SKYE Canyon 11 Parcels 2.16 & 2.17

CITY OF LAS VEGAS		DATE:
INTER-OFFICE MEMORANDUM		June 12, 2019
TO: Land Development Services Department of Building & Safety		FROM: Jennifer Shinn, P.E.  Flood Control Engr. Associate Department of Public Works
SUBJECT: Drainage Study for: Skye Canyon II Parcels 2.16 & 2.17 – Update #2 (Update to DS4842 & DS5000)		COPIES TO: Slater Hanifan Group
Cross Streets:	NEC of Shaumber Rd and Eagle Canyon Ave	Pulte Homes
File Number:	F:\Depot\DSMemos\DS5054B.doc	Bart Anderson, P.E., DevCo
Parcel Number:	126-12-310-001	CCRFCD
Zoning Action:	TMP-72766, TMP-65809	
FEMA Flood Zone	YES NO X	
Proposed Storm Drain	YES X NO

**Subject: Skye Canyon Parcel 2.16 – Storm Drain Revision Justification Letter
(CLV DS4842)**

Subject: Plan Revision Letter for Skye Canyon Parcel 2.16 (DS4842)

PP-3
SHEET 12 OF 27
H#68613
CLV#1075053

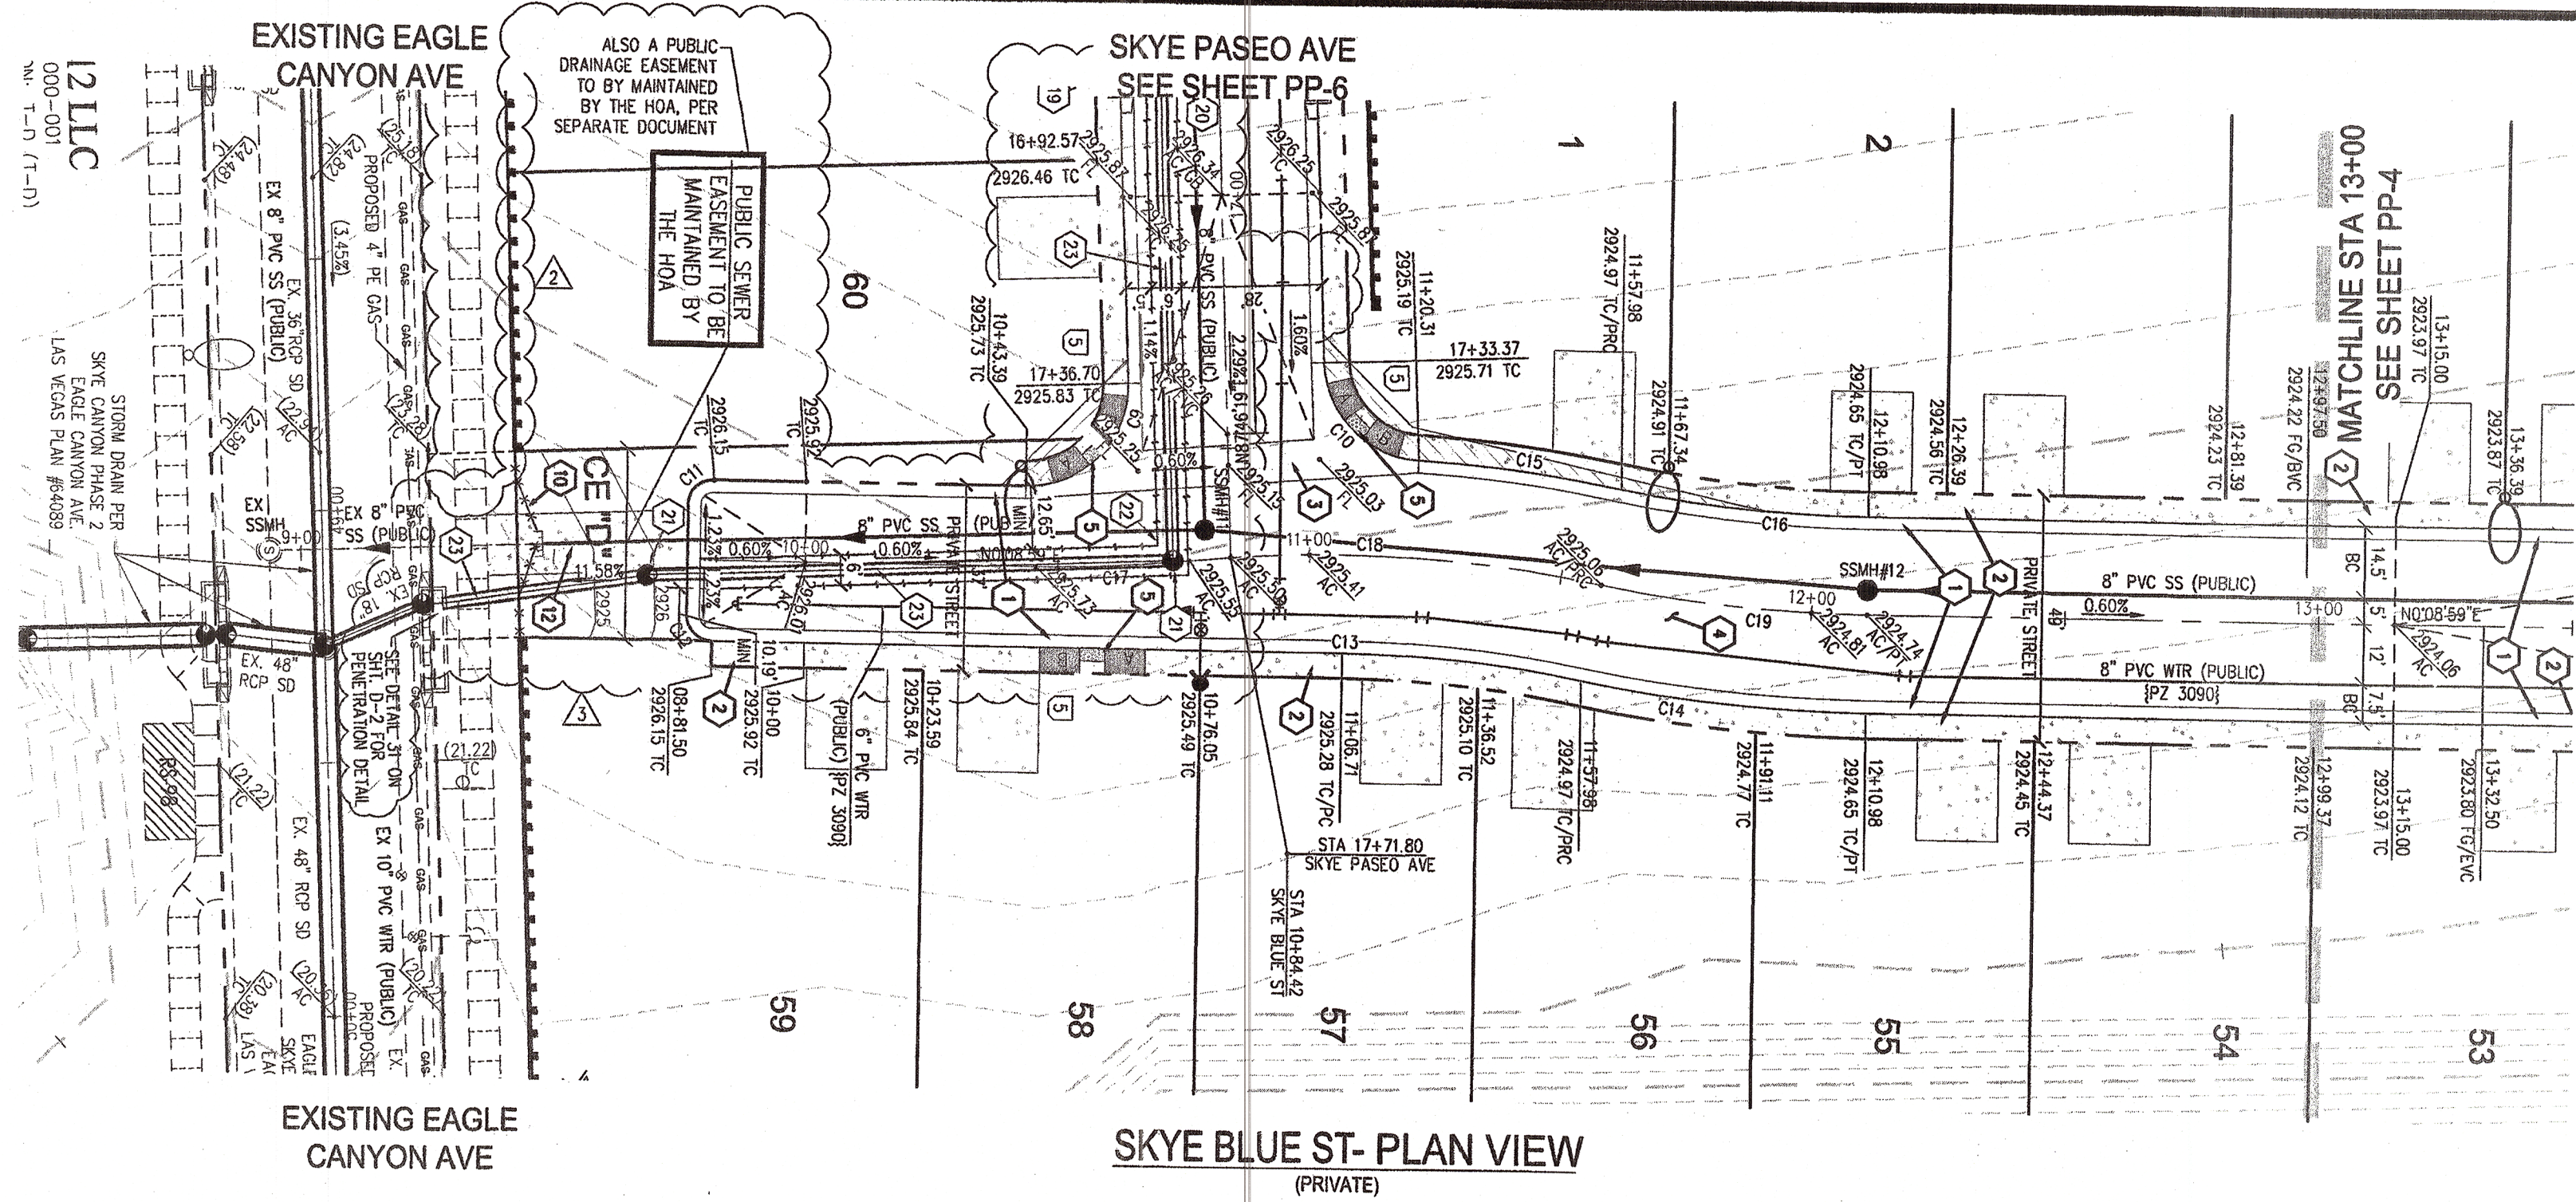
However, upon excavation of trench for the proposed 24" RCP storm drain in Skye Blue Street that will to the back of the existing drop inlet in Eagle Canyon Avenue, it was discovered that the drop inlet invert was constructed approximately 0.27-ft higher than specified on the design plans. Therefore, the 24" RCP invert tying into the drop inlet has to be revised which flattened the pipe slope from 1.50% to 0.80%. The City inspector has requested that a plan revision be processed to address the change. This letter is intended to support the proposed plan revision for the storm drain. The approved WSPGW model for the storm drain has been revised to reflect the revised storm drain invert elevation. The revised storm drain invert is for WSPGW Station 3025.0 and the invert elevation is revised from 2912.36' to 2612.64'. Note that the pipe length remains the same as previously approved. The revised model indicates insignificant change in HGLs and the system still satisfies the required criteria.

Please refer to the accompanying storm drain profile (Sheet PP-3) prepared by Slater Hanifan Group (SHG) for verification. If you have any questions or require additional information, please do not hesitate to contact our office at (702) 284-5300.
